The Commission has issued the enclosed Amendment Nos. 51, 52 and 54 for License Nos. DPR-38, DPR-47 and DPR-55 for the Oconee Nuclear Station Unit Nos. 1, 2 and 3. These amendments are in response to your application dated March 1, 1977 as supplemented December 15, 1977.

The amendments revise the Oconee Technical Specifications to incorporate requirements for fire protection.

AMENDMENT TO FACILITY OPERATING LICENSE

ATTACHMENT TO LICENSE AMENDMENTS

OCONEE NUCLEAR STATION
STATION ORGANIZATION CHART
FIGURE 6.1-1

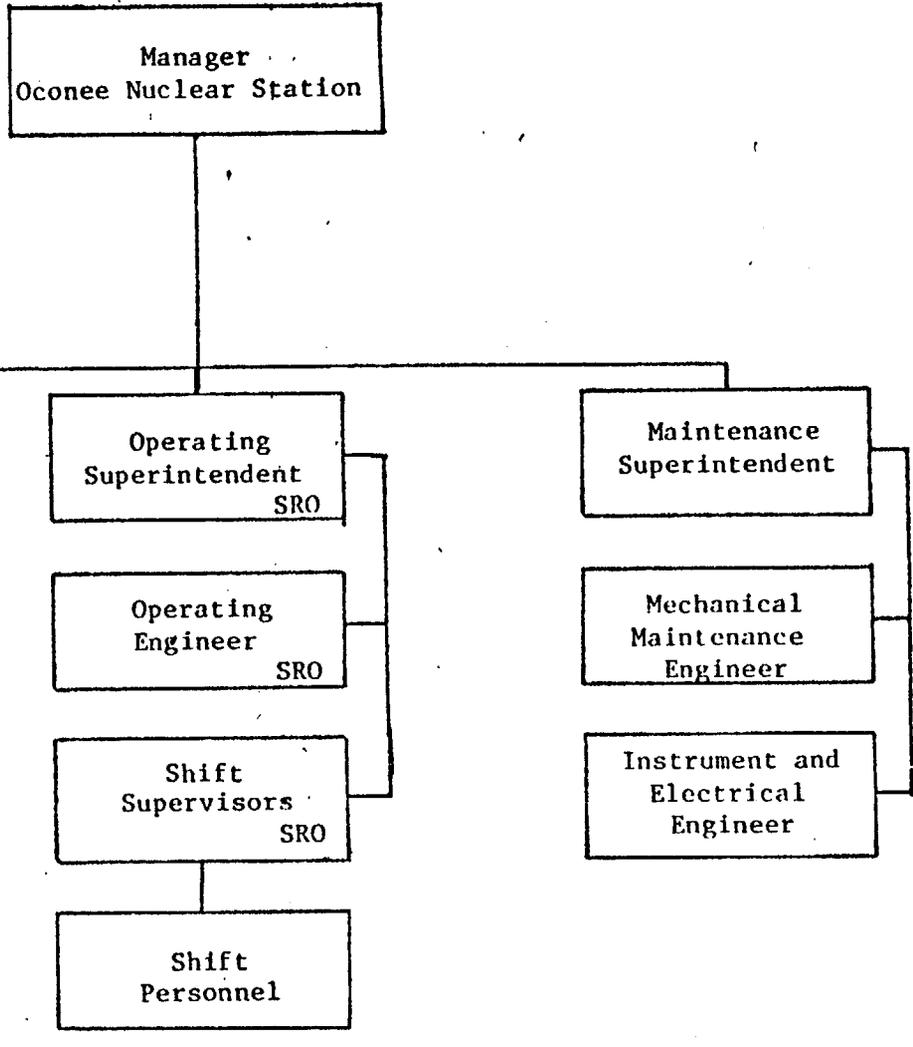
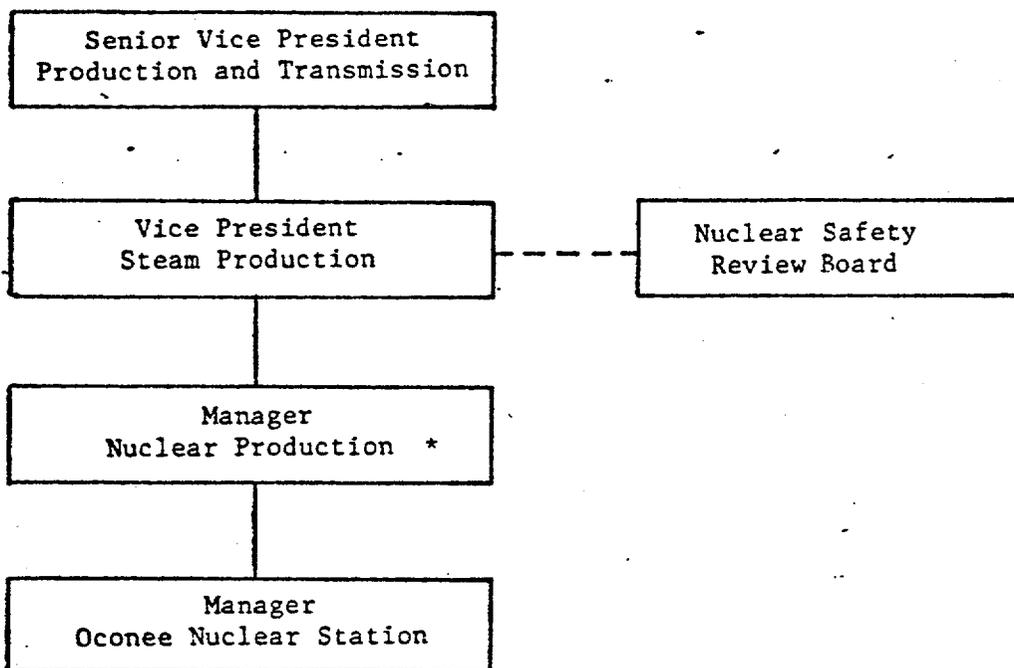
6.1.1.3 The station organization for Operations, Technical Services and Maintenance shall be functionally as shown in Figure 6.1-1. Minimum operating shift requirements are specified in Table 6.1-1.

*Responsible for Fire Protection Program
